General Electric Company
175 Cortner Avenue, San Jose, CA 95125

Docket No. STN 52-001

Subject: Submittal Supporting Accelerated ABWR Review Schedule - DFSE
Chapter 7 Outstanding Item

CLOSURE OF ABWR Draft FSER OPEN AND CONFIRMATORY ITEMS

Figure 7.2-2 REACTOR PROTECTION SYSTEM EQUIPMENT ARRANGEMENT
(From sensors through trip actuators)

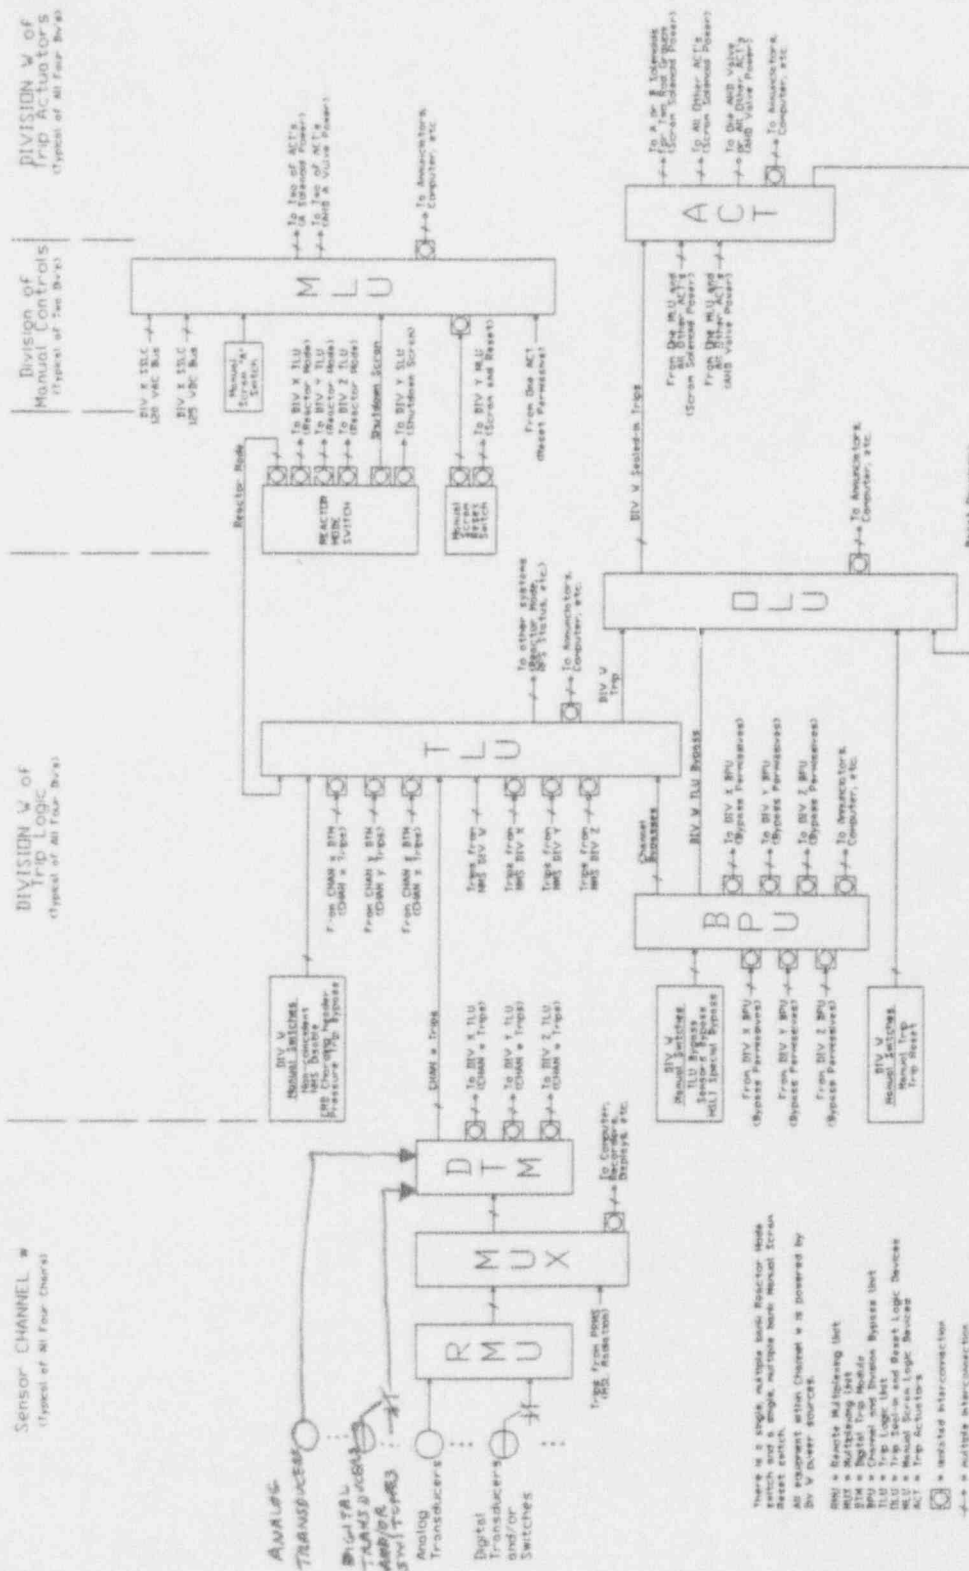
Revise SSAR text and figures to indicate that turbine inputs to SSLC are not multiplexed.

- a. SSAR Section 7.2 revised (see attachment).
- b. Marked-up figures are attached: Figures 7.2-2, 7.2-9a, 7.2-9b. Additional changes shown are hardwired MSIV position switches and deletion of seismic acceleration sensors (not applicable to domestic ABWR design).

except those
from the
Turbine
Building
inverters
and MSIV
position
switches

Figure 7A.2-1 SAFETY SYSTEM LOGIC AND CONTROL (SSLC)

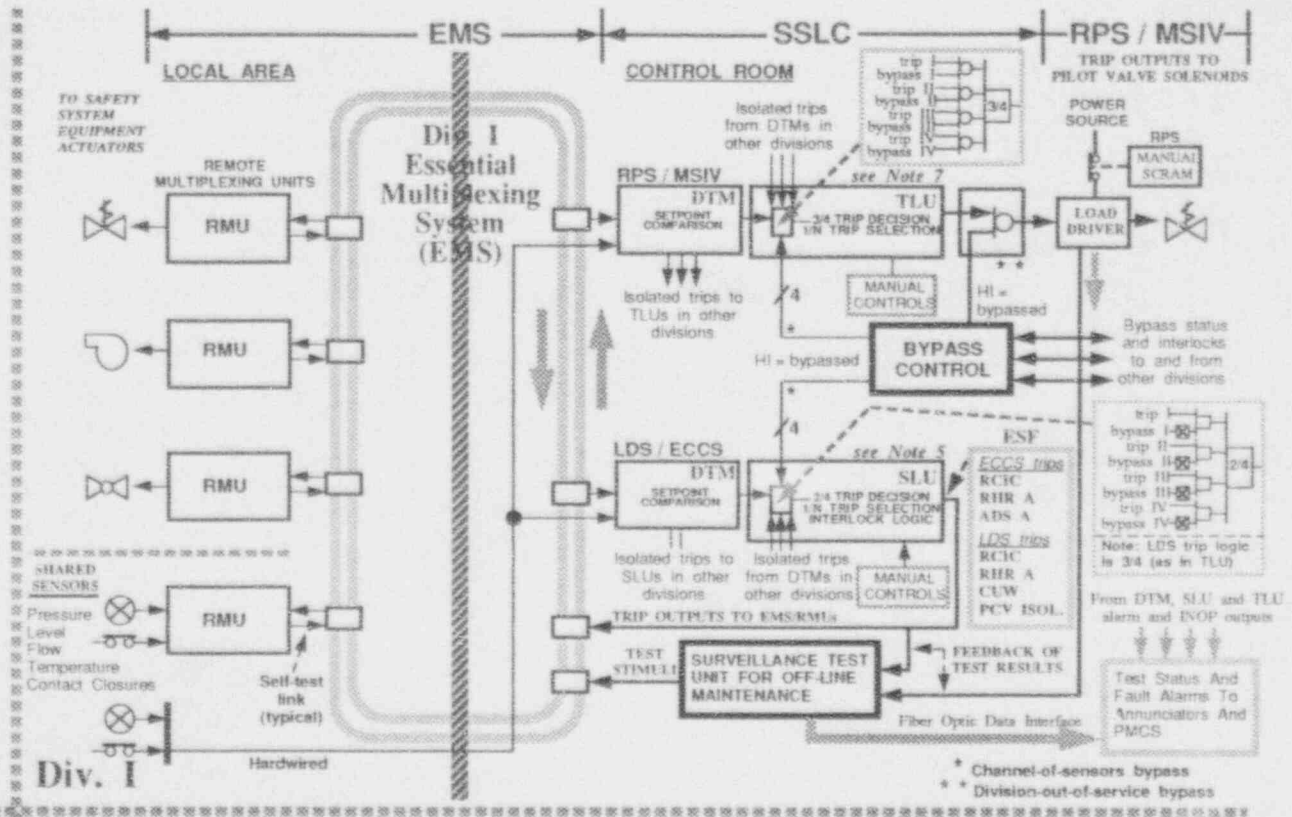
- a. Revise Figure 7.A.2-1 in Appendix 7A to show direct hardwired inputs into DTM.
- b. Revise SSAR to reflect accurate listing of sensors that use EMS.

- a. Revised Figure 7.A.2-1 is attached, showing hardwired inputs.
- b. Revised listing of EMS sensors (April 1993) is attached.

RESPONSE TO DFSEER 7.2.2.2-1
